FD- ST2-USB

Silk Snap & Parts List: PIC16F876A LCD Satellite Tracker & Rotor Controller

ST2 – 0816 PCB error: U4 mounting / SILK ERROR:

Silk Snap of the ST2 - 0816 PCB:

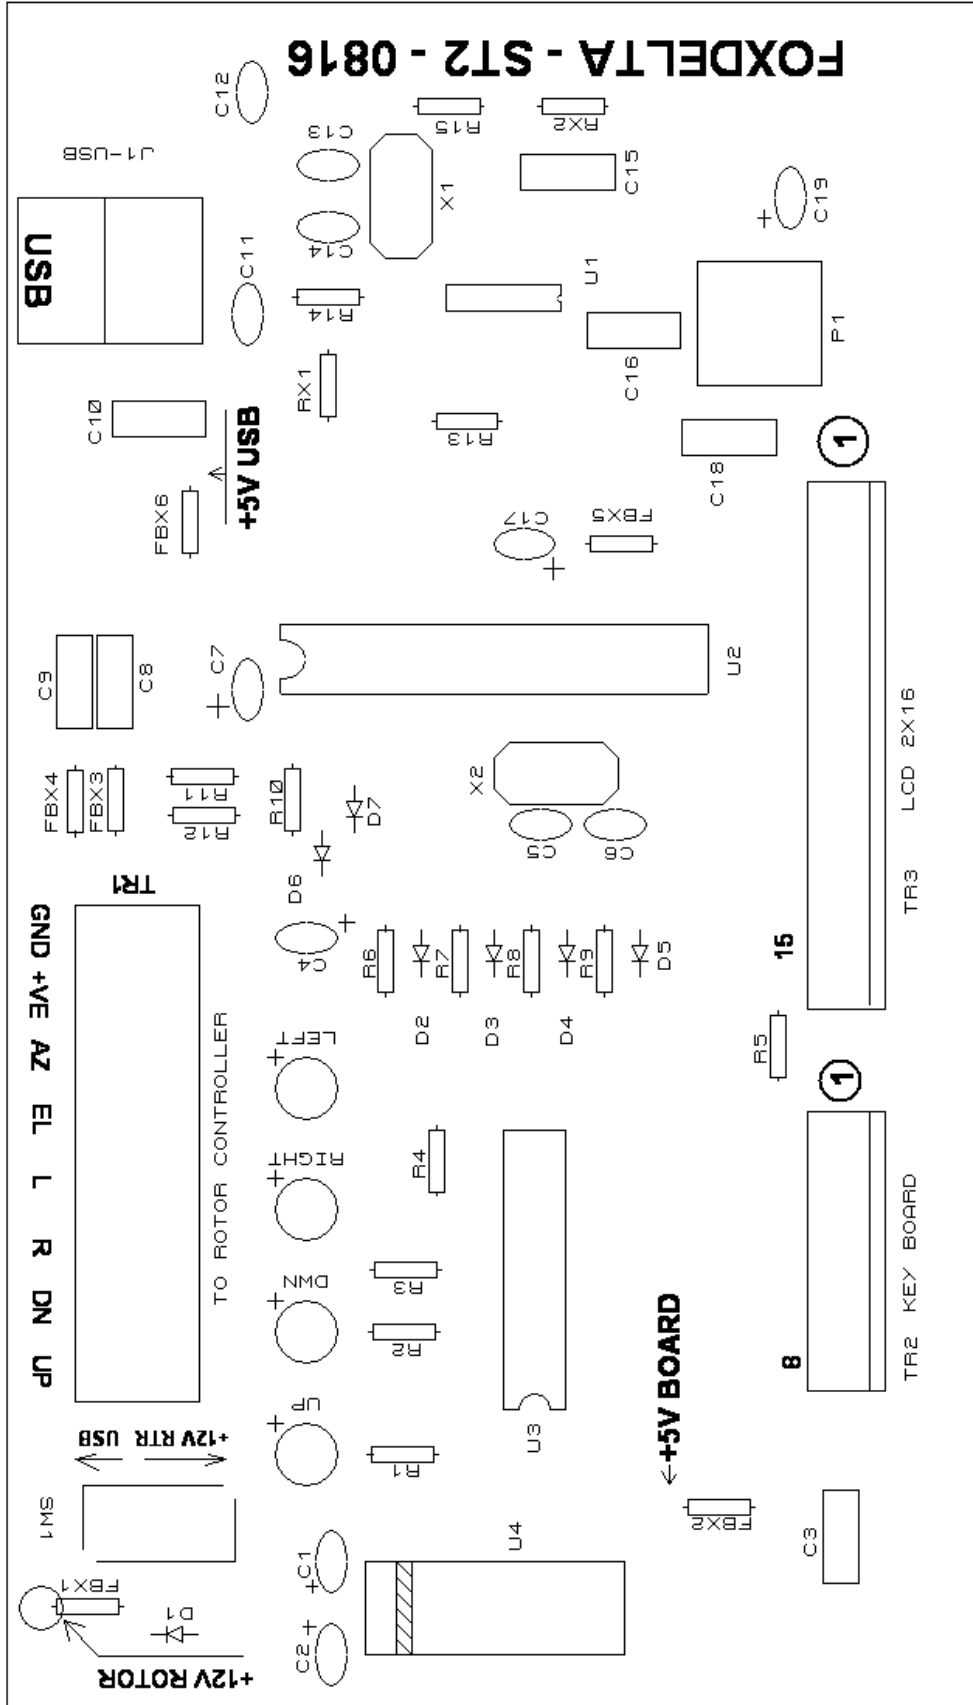
1. LCD Backlight is fix set by R5. You may change this resistor value to increase or decrease backlight brightness. Or remove it for no backlight (Power Saving)
2. Refer to ERROR Document on last page of this document regarding U4/7805. On ST2-0816 PCBs, this regulator must be installed on the solder side.

U4 must be mounted on other side (Solder Side) of the board as detailed and explained in two pictures below:
